CONSERVATION DEPARTMENT DETAILED AGENDA

Date: October 19, 2021

235 Podunk Road

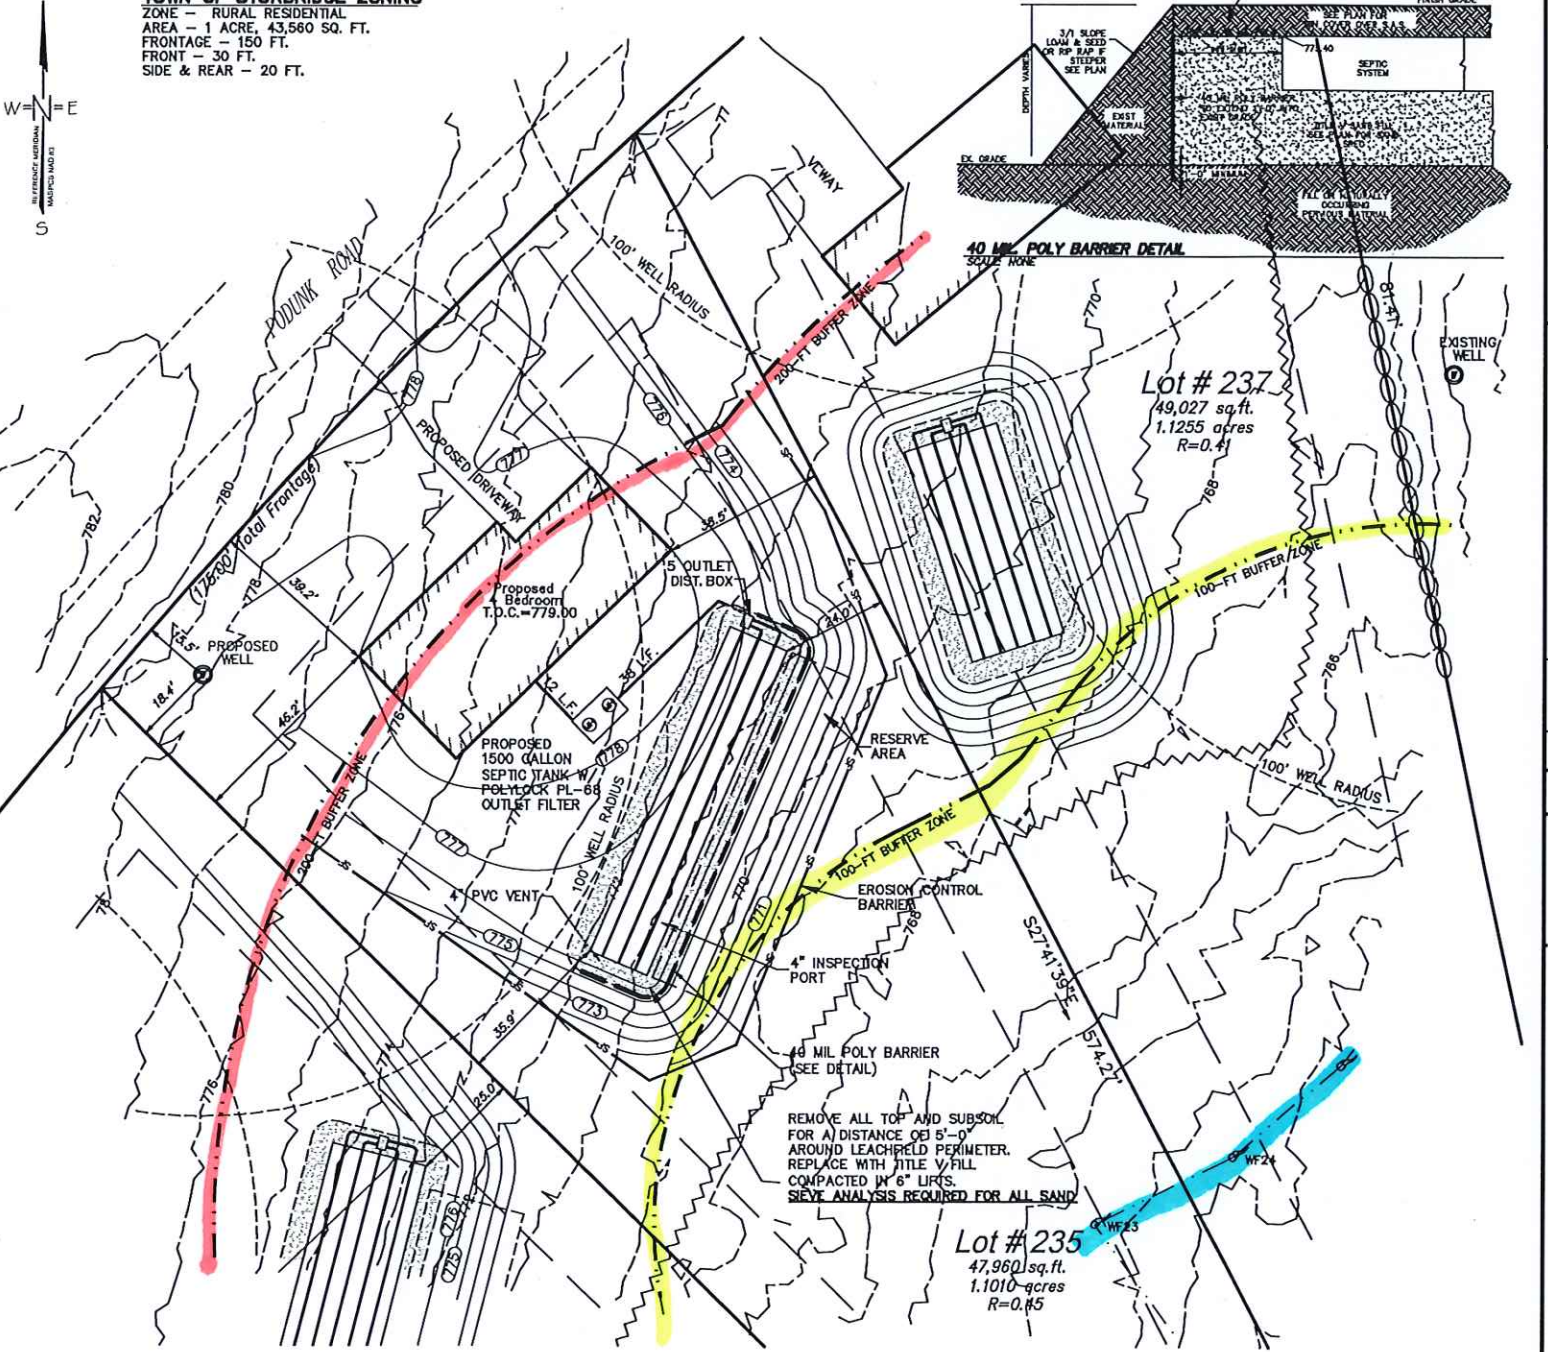
- Proof of abutter notifications received. Proof of Legal Ad verified.
- Project site is an existing field. RDA reviewed at previous hearing. Minor grading associated with the septic install proposed within the WPA 100 ft BZ. Majority of work located within the SWB 200 ft BZ. LOW is approx. 90 feet from the wetland within the gently sloping field.

- Project includes erosion controls at the LOW.
- Staff performed site visit. Could not locate wetland flags. Based on initial review, it appears that the wetland line may be closer to the field/wooded area line and therefore closer to the development. Flags should be re-hung, area further reviewed and BVW data sheets submitted.

- Staff Recommendations: Take no action at this time, until additional information is presented. Project may require NOI under the WPA. Continue hearing to allow for additional information to be submitted. If information cannot be submitted by Nov. 9th, project should be continued out 2 meetings (Dec. 7th).

29 Valley Road

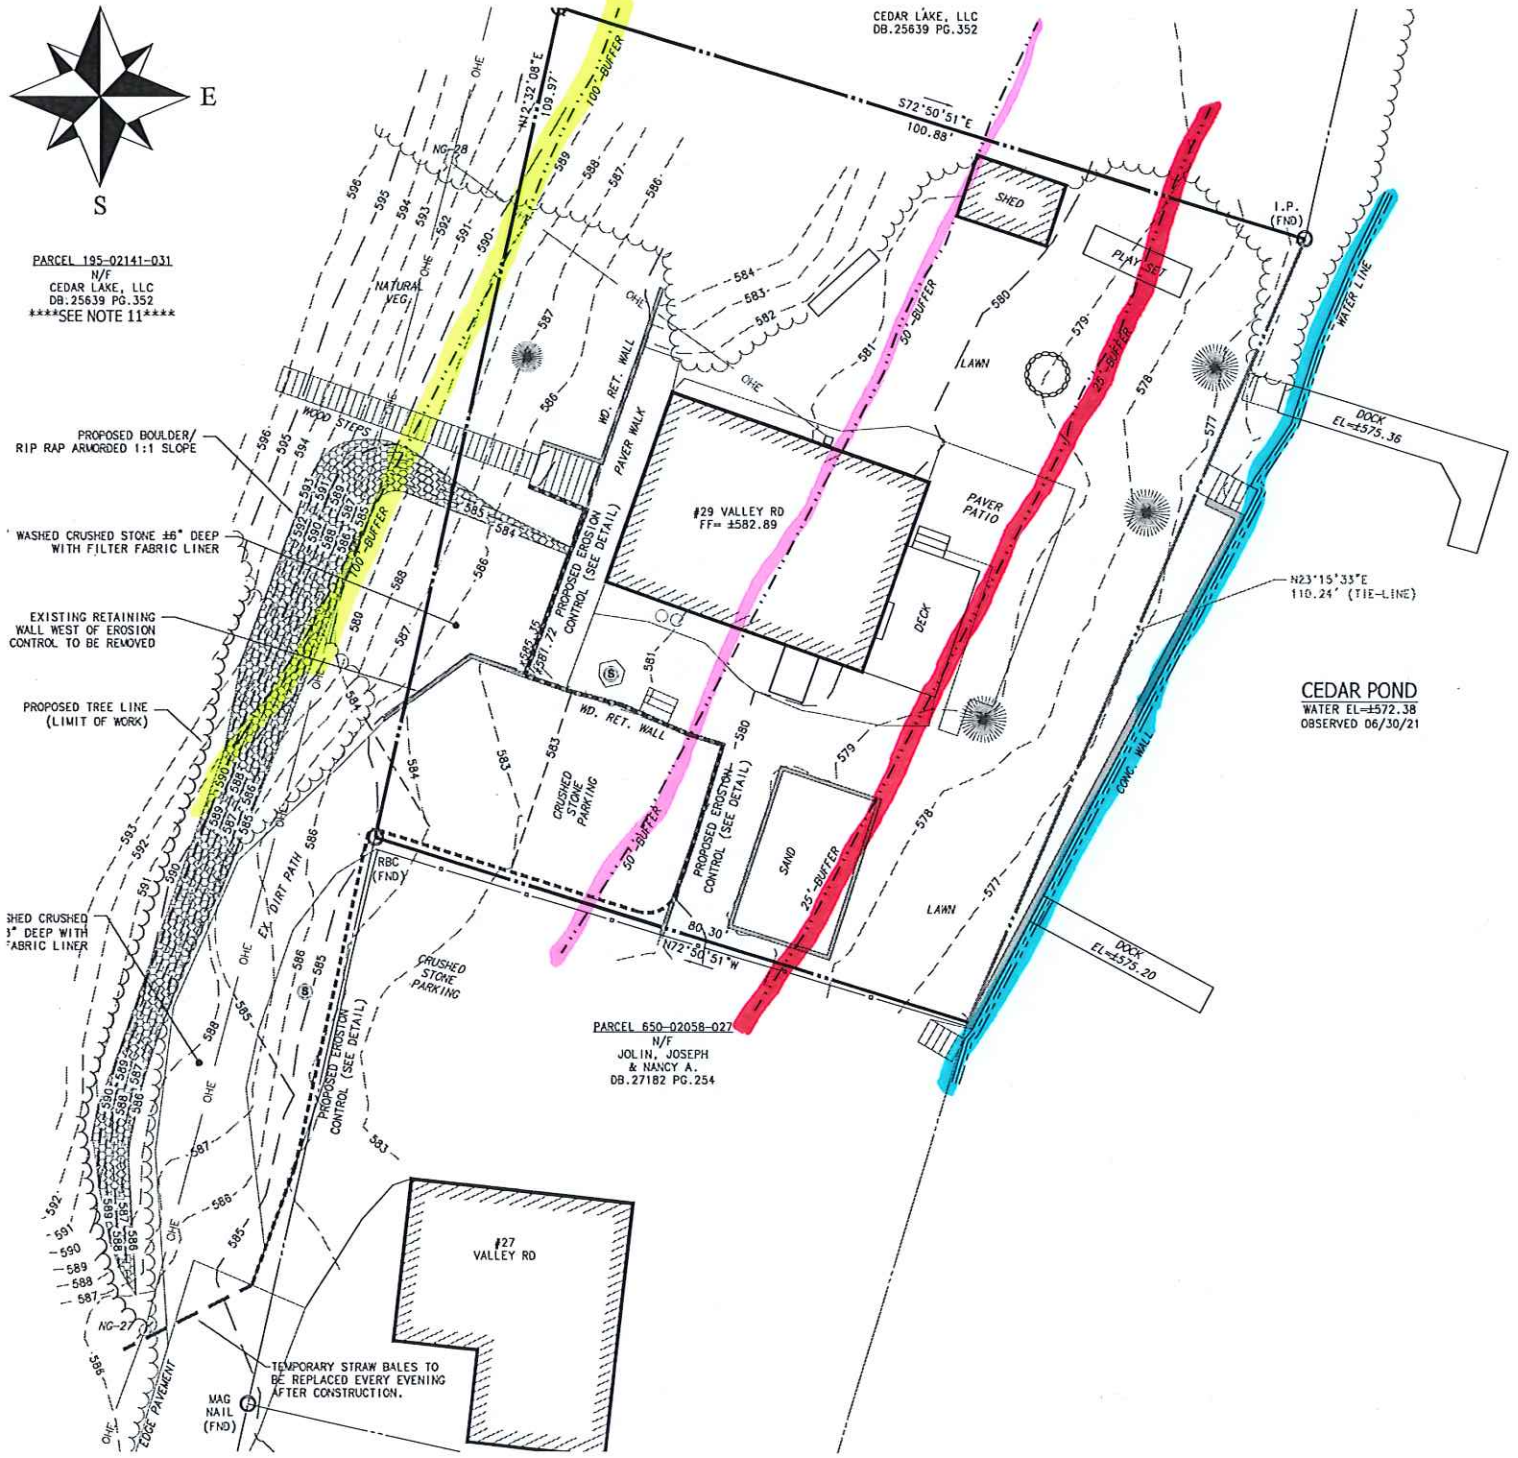
Site appears to be in Bordering Land Subject to Flood and this is not depicted on the site plan, please revise with BLSF delineated on plan. If proposed work is in BLSF, the applicant should demonstrate how work complies with 310 CMR 10.57.

As Cedar Pond is a listed Great Pond, if existing concrete wall falls within the Mean Annual High Water line, i.e. the wall will be in contact with the waterline during a typical year, the wall may require a Ch. 91 license. Existing dock(s) may also require Ch.91 licenses if they do not already exist.

- Staff would recommend asking if there are any alternatives to rip rap on the slope? Can this be seeded and covered w/ an erosion control blanket?
- Revised plan received with BLSF. Work is not within.
- Staff Recommendations: Provided no viable alternative to the rip-rap as noted above, staff would recommend closing the public hearing and approving the project through the issuance of a OOC with the following conditions:
 - Standard OOC conditions
 - Include an entrenched silt fence with the straw wattle on the plan.
 - No stockpiling of excavated materials on site.

76 Stallion Hill Road

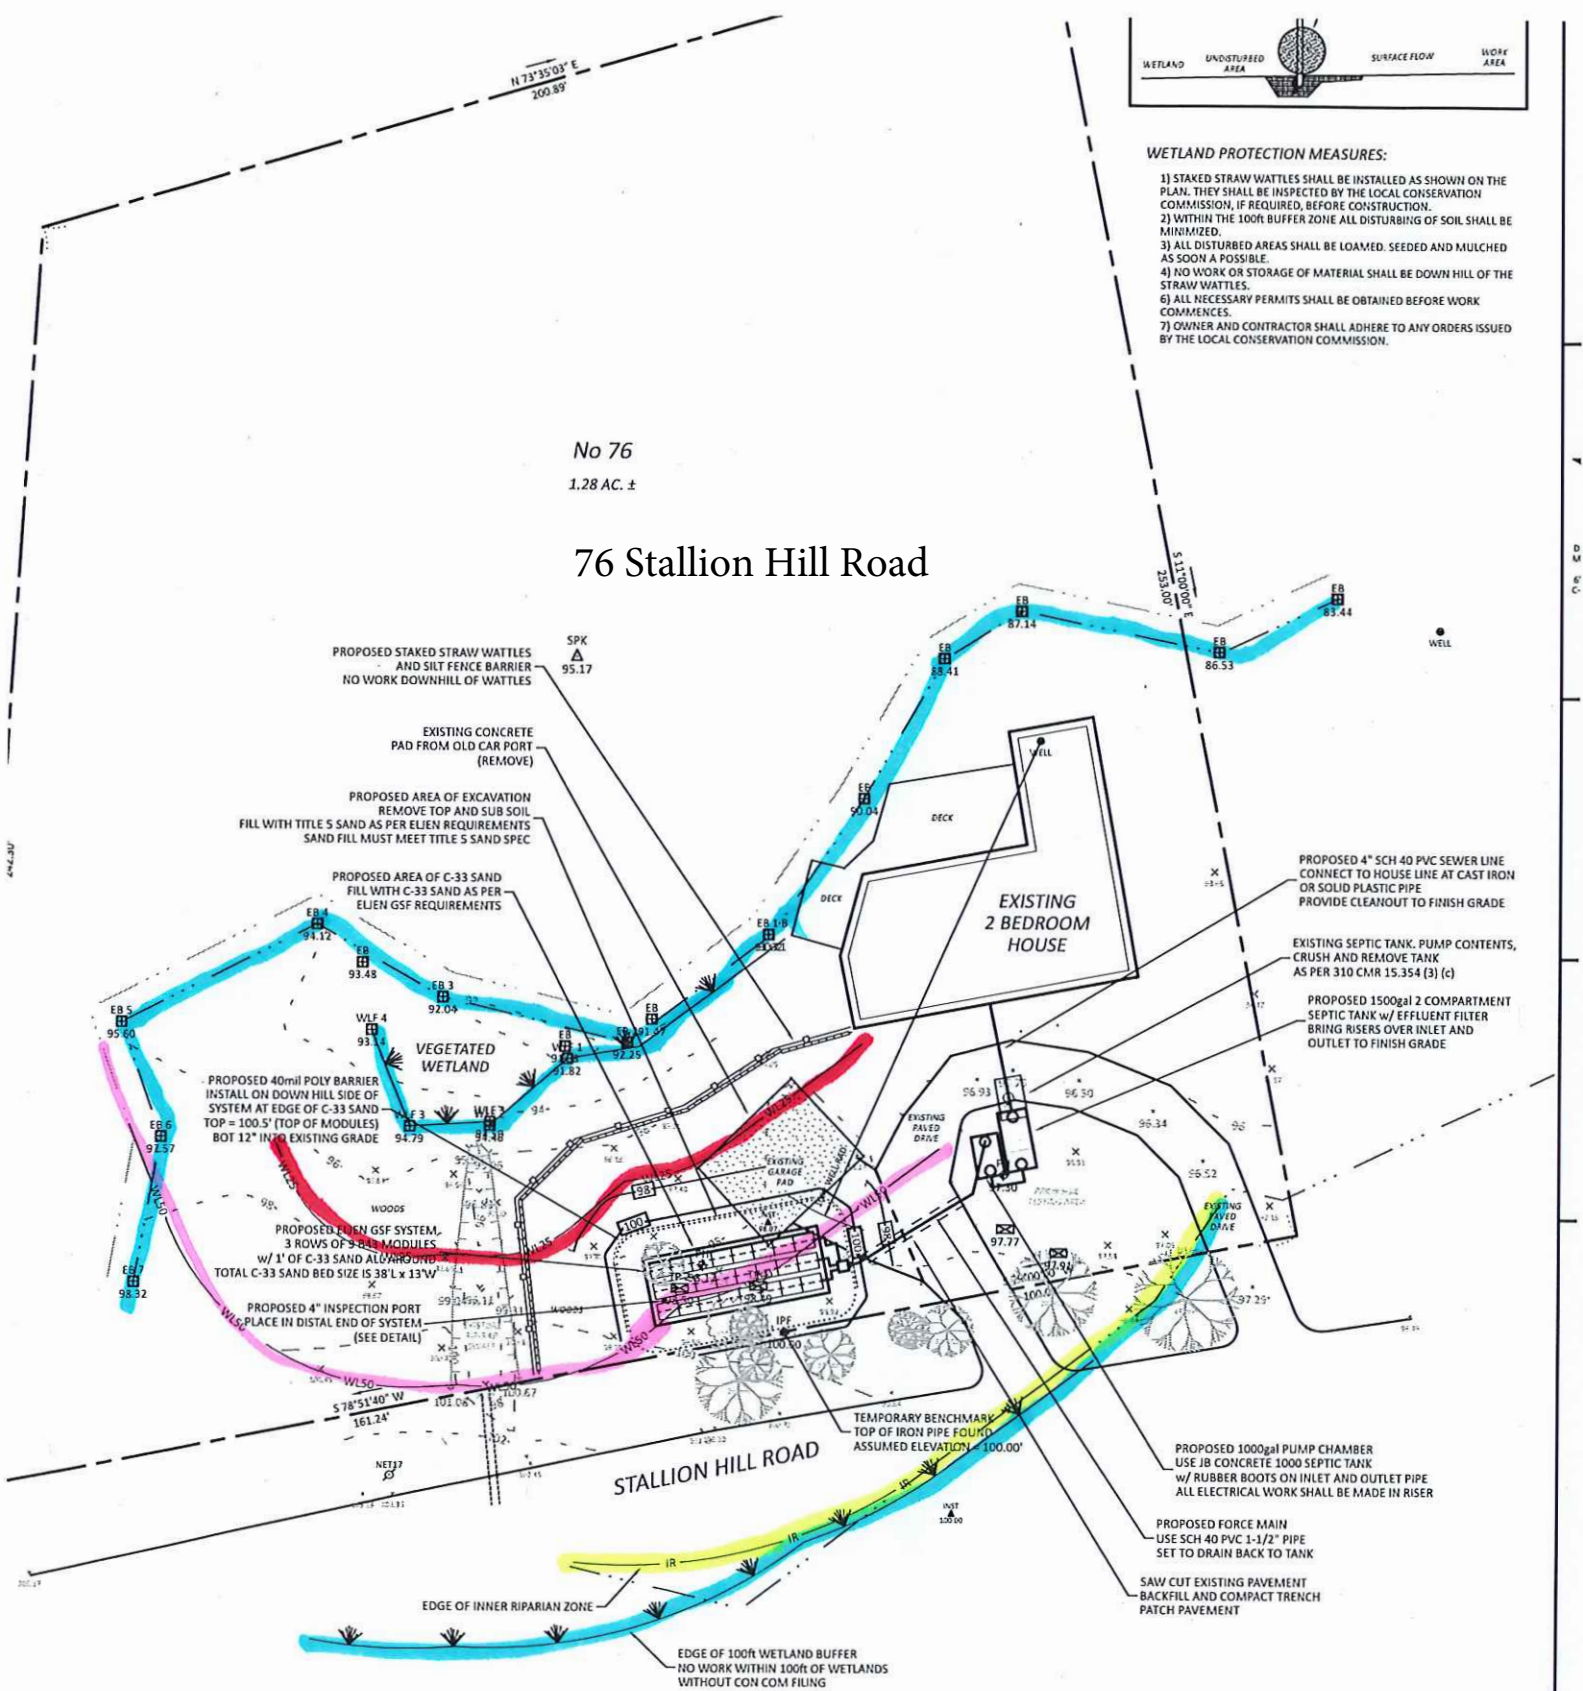
- Similar septic replacement previously approved here under DEP File #300-813. Work was not completed and permit has expired. System was proposed in different location (SE side of site) which is further from the wetlands. Was within 100 ft well setback for this property’s well.

- There is an existing swale shown from road which discharges into the wetland. Staff looked at to see if jurisdictional. Swale feeds out of a wetland on opposite side of the road. This would be jurisdictional. Plan should be revised to flag this area. The LOW is 3 feet of this area. Citing of septic would appear to be of concern due to proximity to the wetlands.

- Project would appear to meet exemptions from Riverfront Area requirements under 321 CMR 10.58(6)c. Still jurisdictional within the buffer zone.
 - Plan requires review with BOH and appears to require a variance as it does not meet 50 ft setback from wetlands. System proposed is a ELJEN GSF System. System requires a pump. BOH should be consulted on system location prior to SCC closing the hearing.

- Deck over the brook requires footing repairs. This deck was likely installed without permitting. Staff spoke to new owners and recommended looking at removal of this section. Staff reviewed on site and recommend removal. Staff also recommend removal of the dilapidated bridge over the stream and removal of trash in and around the wetlands from former owners. The board should weigh in on this.

- Board should see if they want to perform a site visit next week as it was missed or if they want to wait at this time. Site is staked for review.
- Staff Recommendations: Alternatives to move the system further from the wetlands should be explored, plan revised to reflect stream (flag Bank), and BOH consulted. Silt fence should be installed vs. just wattles. Continue the hearing to address comments. If information cannot be submitted by Nov. 9th, project should be continued out 2 meetings (Dec. 7th).
